REPORT TO THE PLAN COMMISSION

Site Plan

Project Name:	Matt Talbot Recovery Services, Inc. CBRF
Project Location:	9132 South 92 nd Street
Property Owner:	Shinken, Leo & Milton
Applicant:	Matt Talbot Recovery Services, Inc.
Agent:	Nathan Laurent, Keller, Inc.
Current Zoning:	R-3 Suburban/Estate Single-Family Residence District and C-1 Conservancy District
2025 Comprehensive Plan:	Areas of Natural Resource Features
Use of Surrounding Properties:	Single-family residential to the north, south and west and vacant land zoned B-2 District to the east
Applicant's Action Requested:	Approval of Site Plan Application for the construction of a 5 bedroom CBRF development

A RESOLUTION APPROVING A SITE PLAN FOR A 5 TO 8 BEDROOM STATE
LICENSED COMMUNITY BASED RESIDENTIAL FACILITY DEVELOPMENT
(9132 SOUTH 92ND STREET)
(MATT TALBOT RECOVERY SERVICES, INC., APPLICANT)

FIGURE 2
 NATURAL RESOURCES PROTECTION PLAN

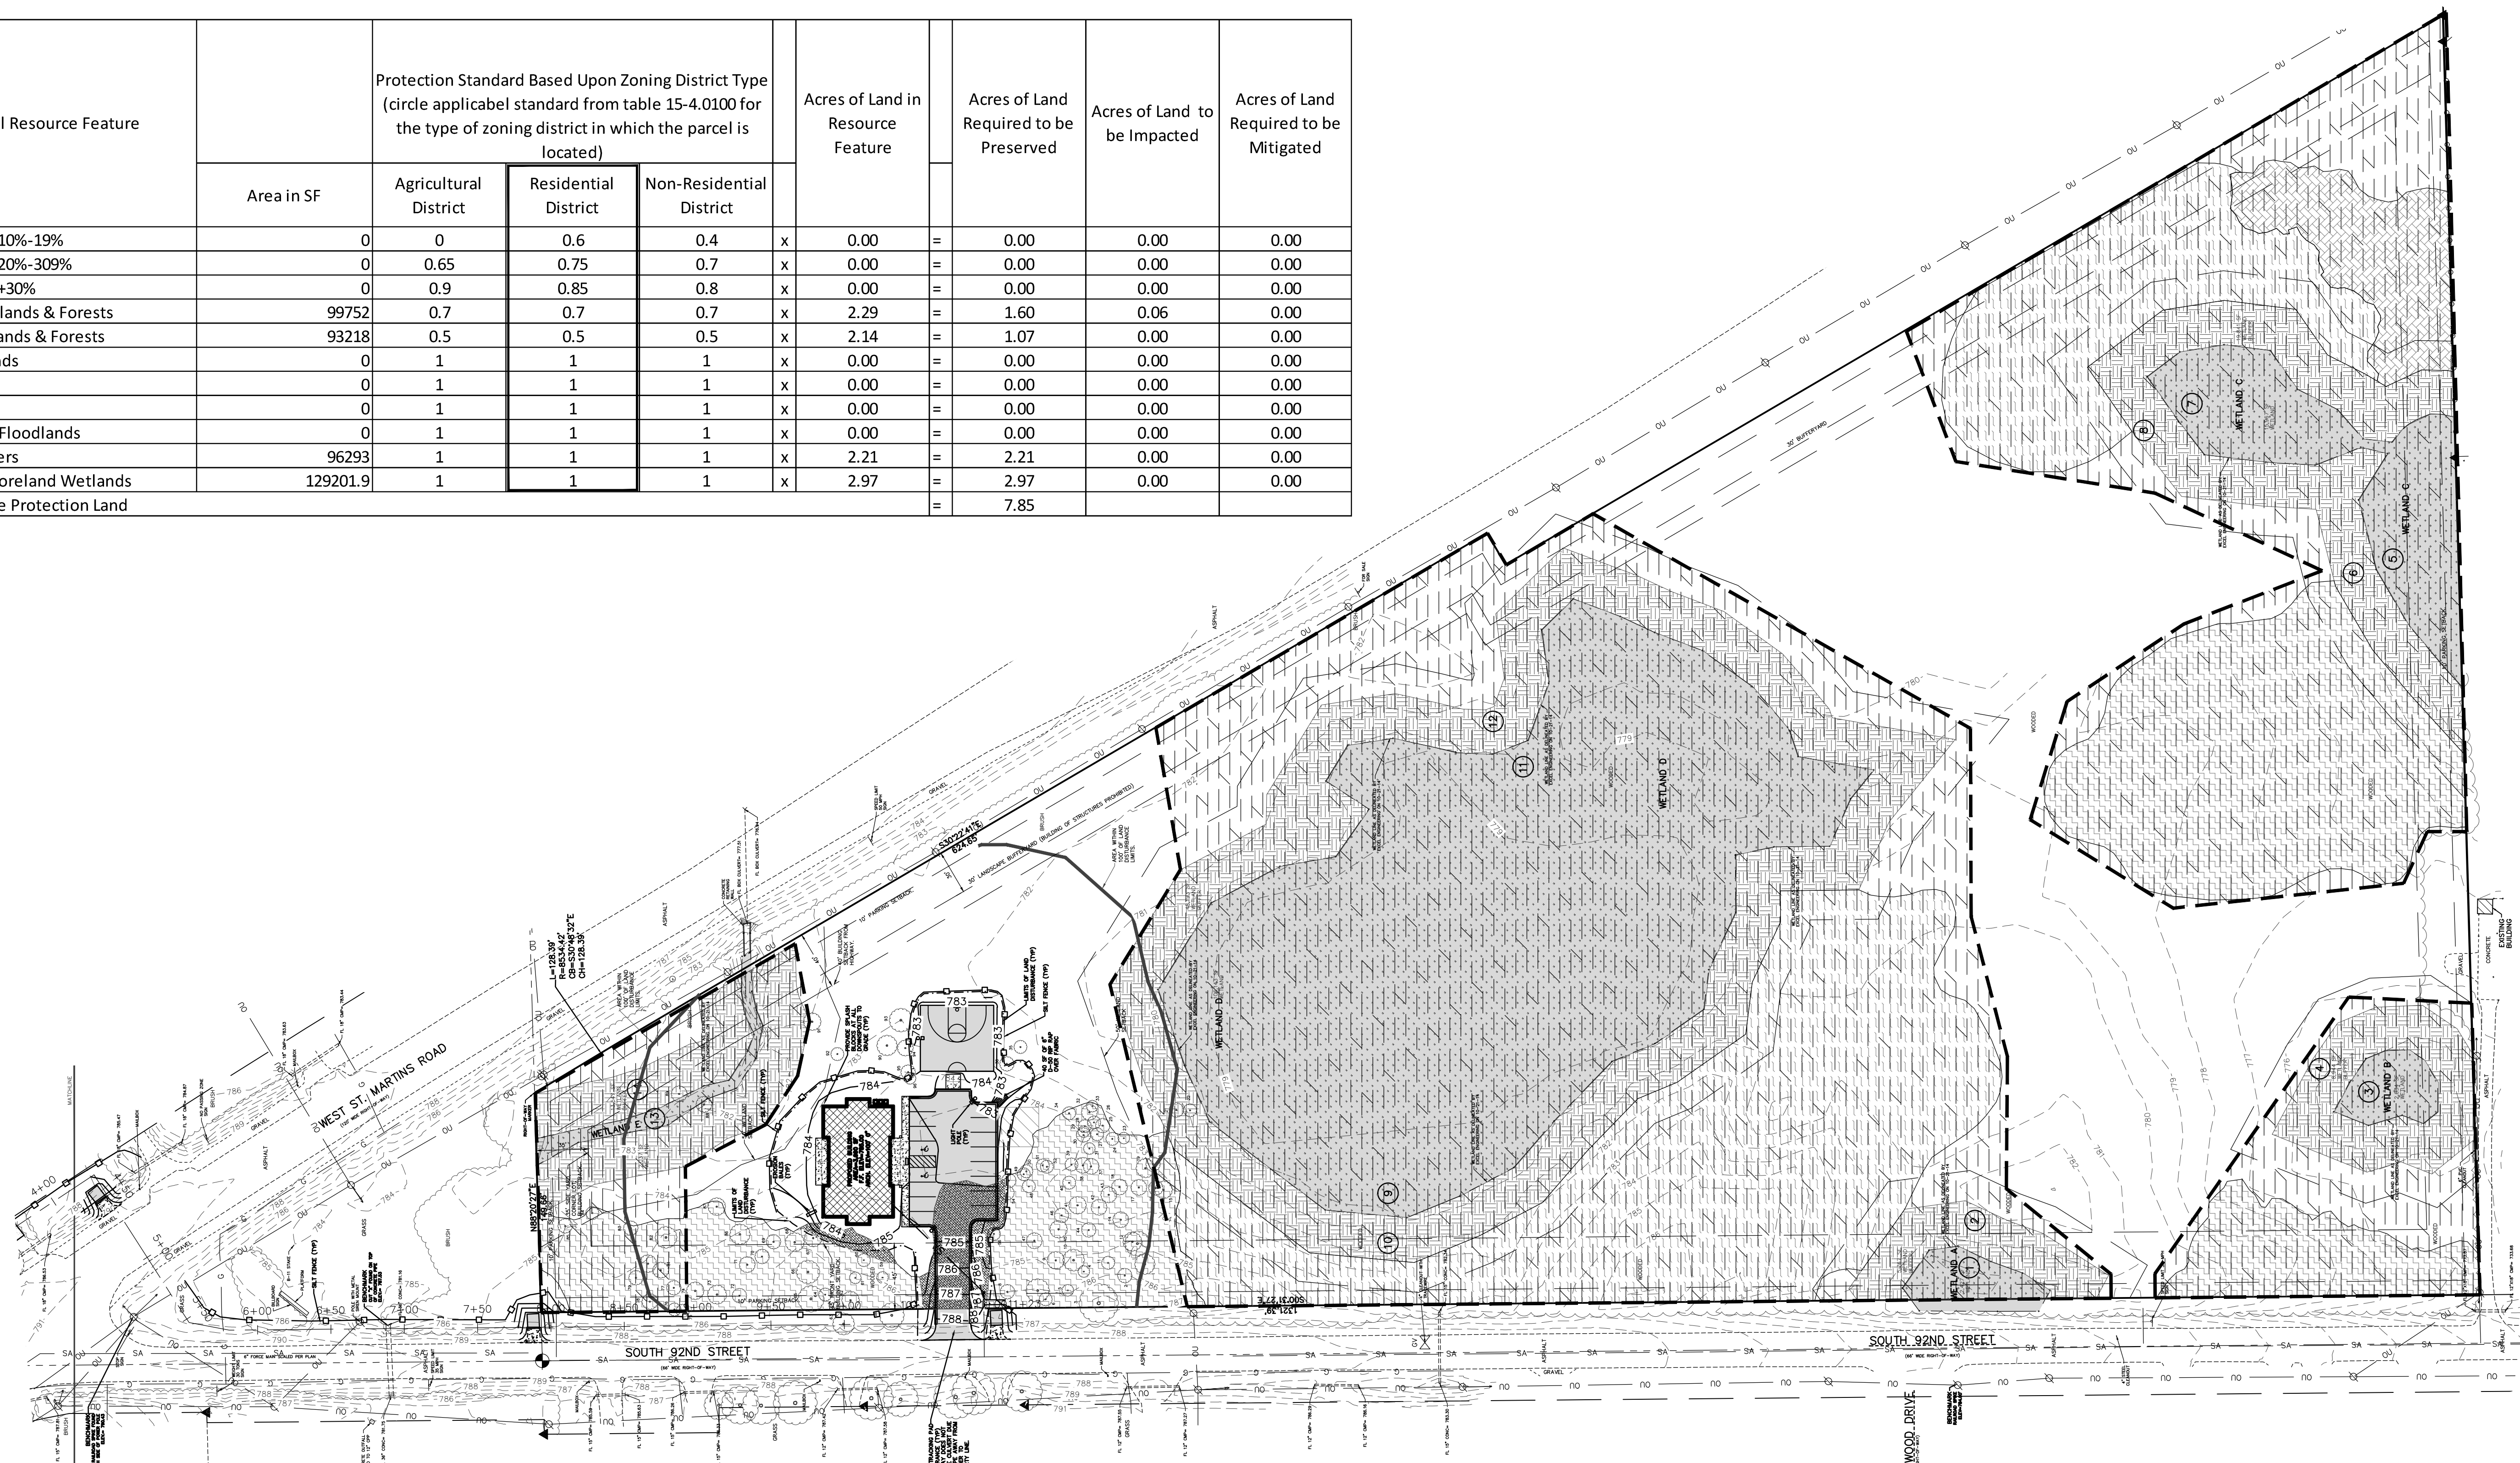
The applicant has submitted a Natural Resource Protection Plan. The site contains several protected resources including: mature woodlands, young woodlands, wetlands, wetland buffers and wetland setbacks.

The development is fully protecting the young woodlands, wetlands, wetland buffers and wetland setbacks. The applicant is proposing to protect 71% of the mature woodlands within a conservation easement, which is in compliance with the UDO mature woodland protection standard of 70%. The proposed development will remove 3 trees or 2.6% of the mature woodlands onsite; however, for preparation of the conservation easement, the applicant is proposing to not include undisturbed mature woodland areas along S. 92nd Street adjacent to the proposed development.

7. A Natural Resource Protection Plan shall be submitted by the applicant and shall be subject to City consultant review and approval by Department of City Development staff, prior to the issuance of a Building Permit.
8. Applicant shall submit a Conservation Easement for review and approval by the Common Council and recording with the Milwaukee County Register of Deeds, prior to the issuance of an Occupancy Permit.
9. A cement siding product shall be utilized (as opposed to the vinyl siding proposed by applicant).

SHEET: **C1.4**

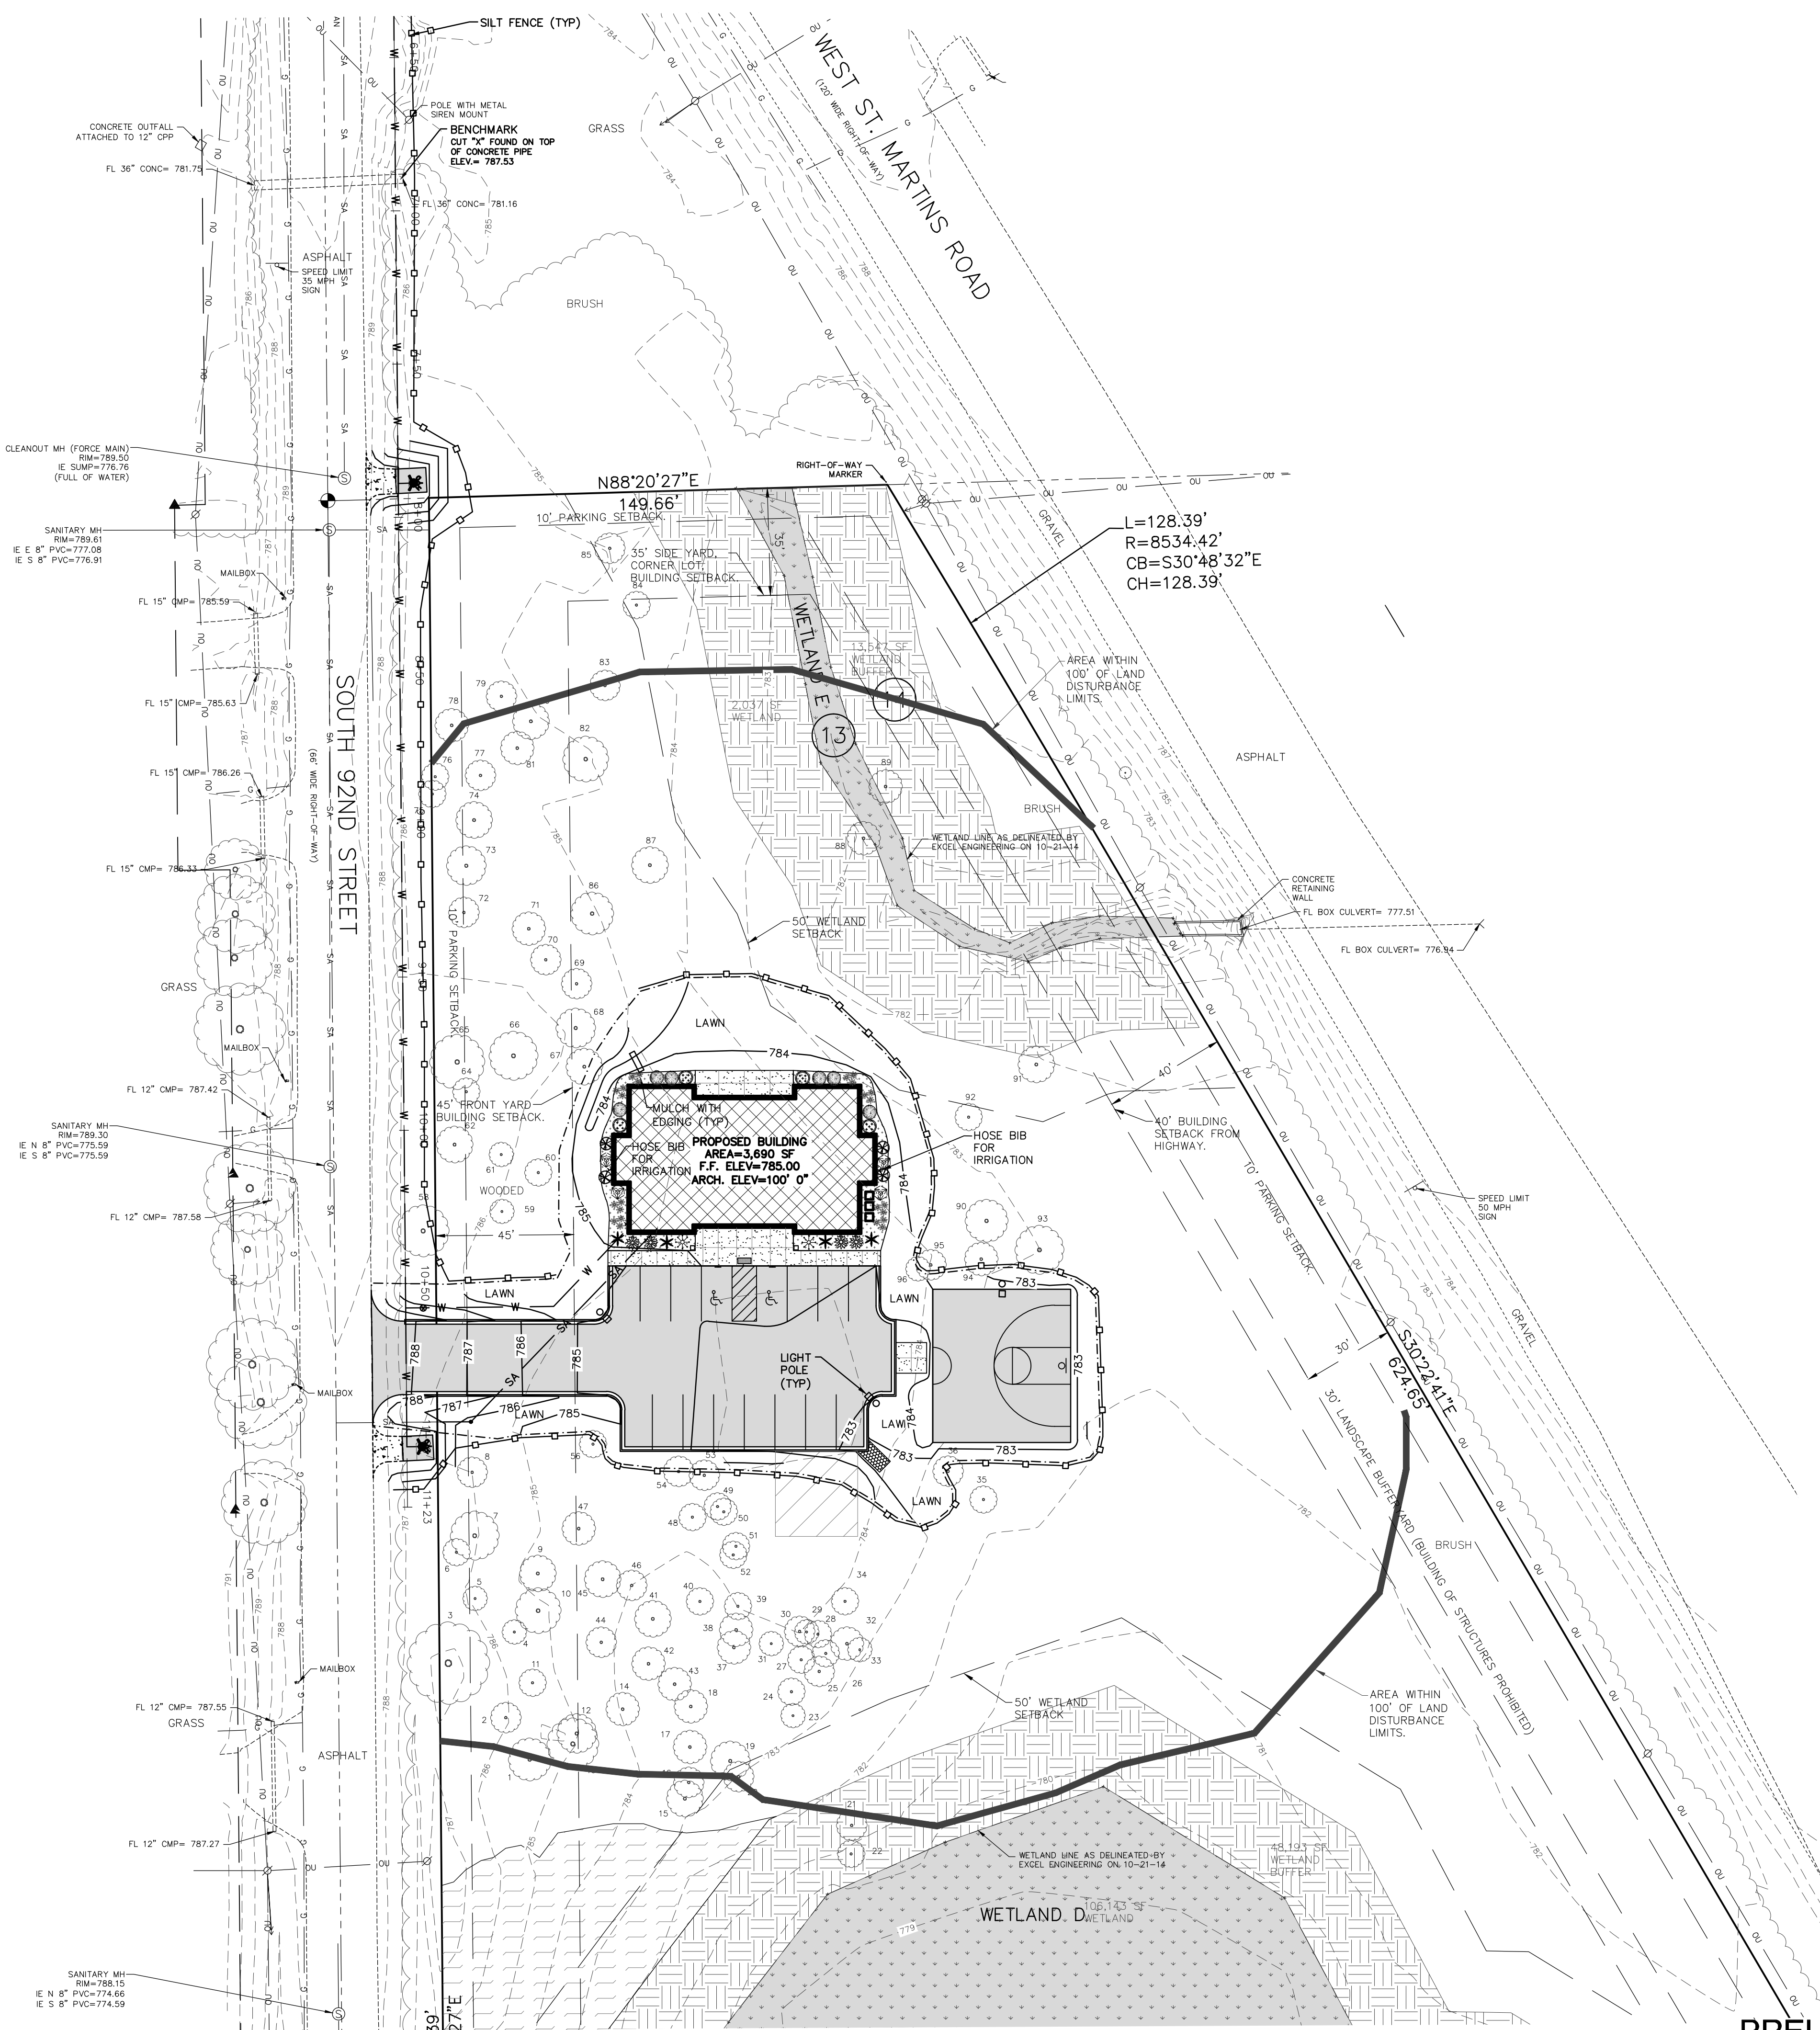
However, from a land use standpoint, the use is comparable to institutional and multi-family uses and staff would suggest landscaping be provided to meet institutional land use standards. Table 15-5.0302 of the UDO requires one planting of each type (canopy/shade tree, evergreen tree, decorative tree and shrub) per five provided parking spaces for Commercial, Office, Institutional and Similar Uses. With 16 parking spaces provided, a minimum of 4 plantings of each type are required.

The applicant is providing foundation plantings consisting of 14 deciduous shrubs, 8 evergreen shrubs and perennials. The site is heavily wooded and a tree survey was completed extending 25 feet from the project area. The tree survey lists 97 trees with a DBH greater than eight inches. As Section 15-5.0302D. of the UDO allows credit for preserved existing plant materials, the landscaping standards could potentially be met by crediting existing plantings. The applicant would have to identify a sufficient number of plantings for each plant type.
